**SUNDRY NOTICES AND REPORTS ON WELLS**  
Do not use this form for proposals to drill or to re-enter an abandoned well. Use form 3160-3 (APD) for such proposals.

8. Well Name and No.  
BIG EDDY UNIT 150

XTO Permian Operating LLC respectfully requests to PA the above referenced well.

\*\* BLM REVISED \*\* BLM REVISED \*\* BLM REVISED \*\* BLM REVISED \*\* BLM REVISED \*\*

# Big Eddy Unit #150 - Current and Proposed WBD's

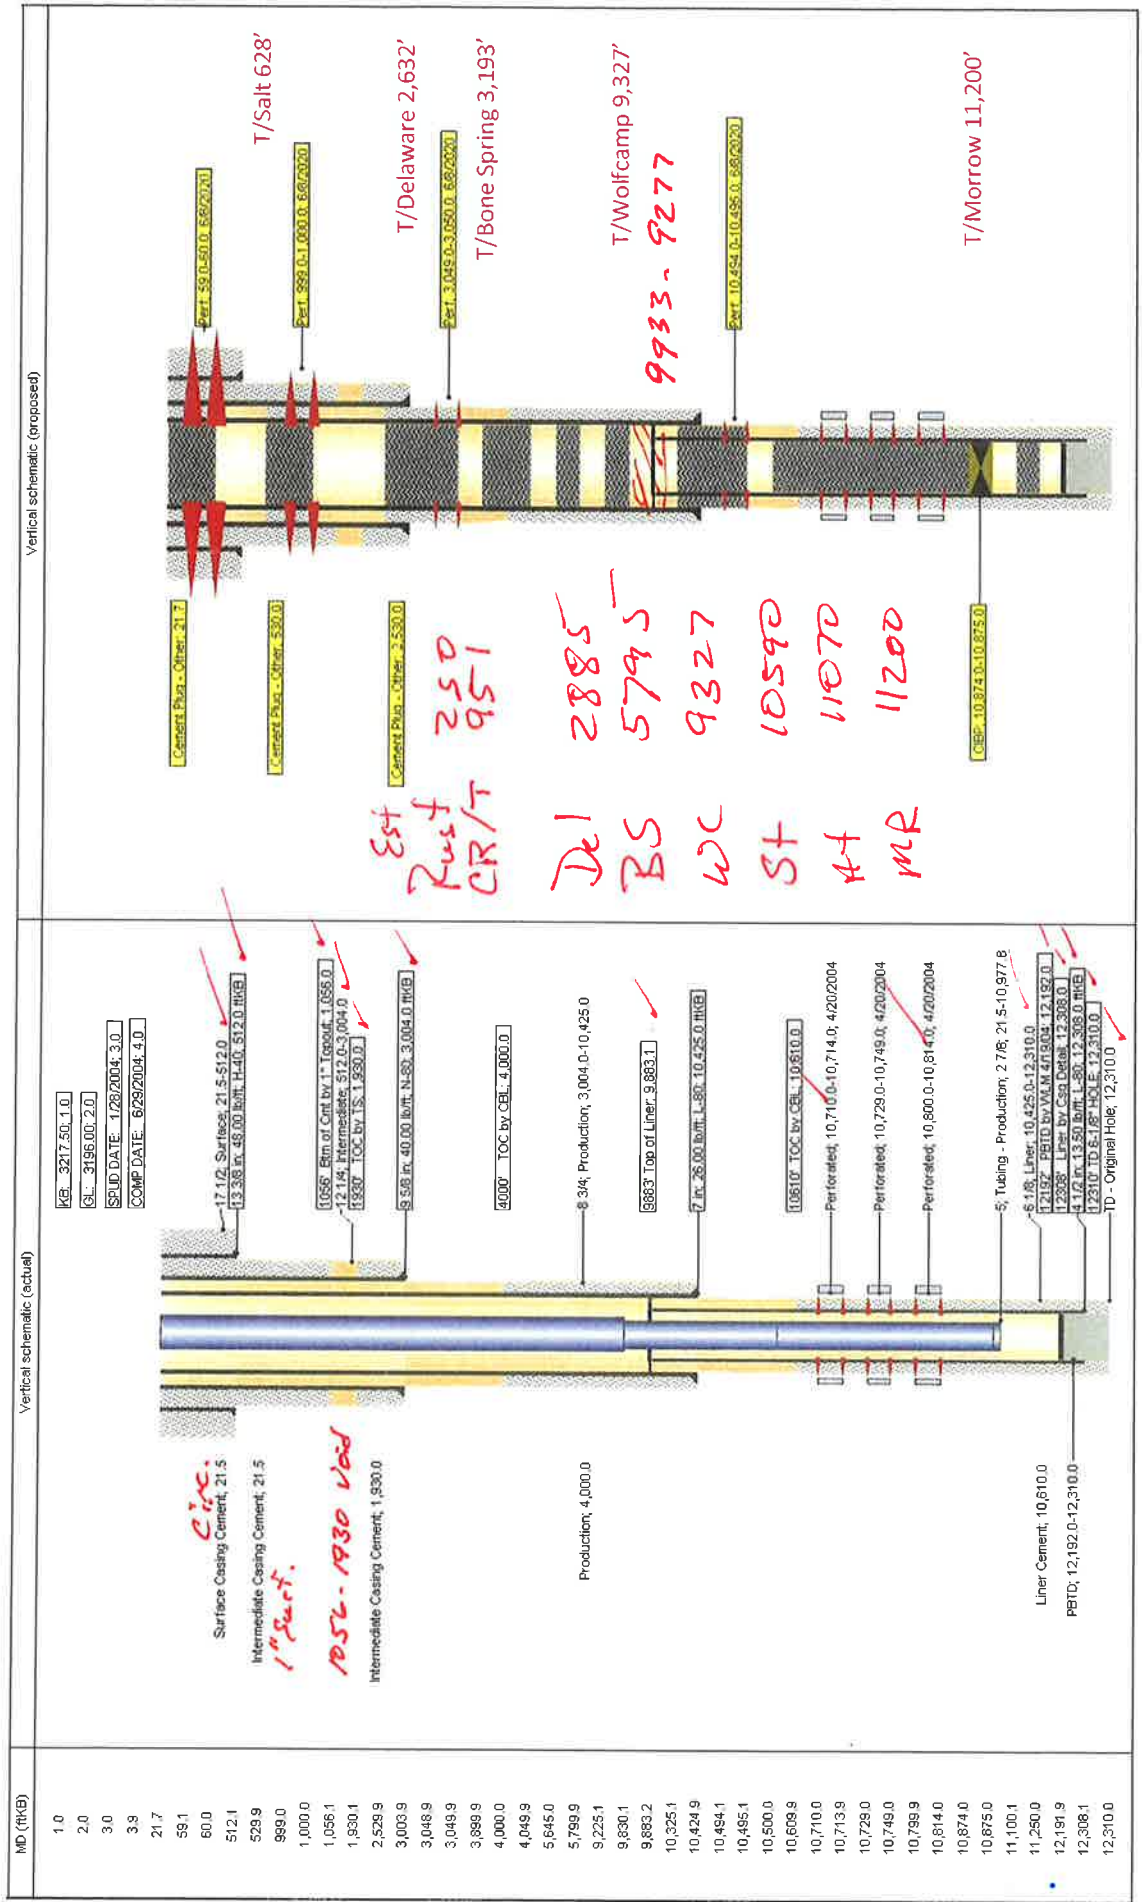
- 8) PUH w/tbg to ~~9,830?~~ <sup>9933</sup> and spot 100 sxs Class H cmt. WOC and Tag at least ~~9,225?~~ <sup>9277</sup>. (T/Wolfcamp, 4-1/2? Liner Top)

- 9) PUH w/tbg to ~~5,800?~~ <sup>5845</sup> and spot 25 sxs Class C cmt. WOC and Tag at least ~~5,645?~~ <sup>5685</sup>. (T/Bone Spring)
- 10) PUH w/tbg to 4,050? and spot 25 sxs Class C cmt. WOC and Tag at least 3,900?. (TOC) *NOT Required.*

- 11) POOH w/tbg, RU WL, and RIH WL. Perf 7? csg at 3,050? and squeeze 170 sxs Class C cmt. WOC & Tag at least ~~2,530?~~ <sup>2835</sup>. (T/Delaware, 9-5/8? Casing Shoe)

- 12) POOH w/tbg, RU WL, and RIH WL. Perf 7? csg at 1,000? and squeeze 150 sxs Class C cmt. WOC & Tag at least ~~530?~~ <sup>462 (13 3/8" shot)</sup>. (T/Salt)
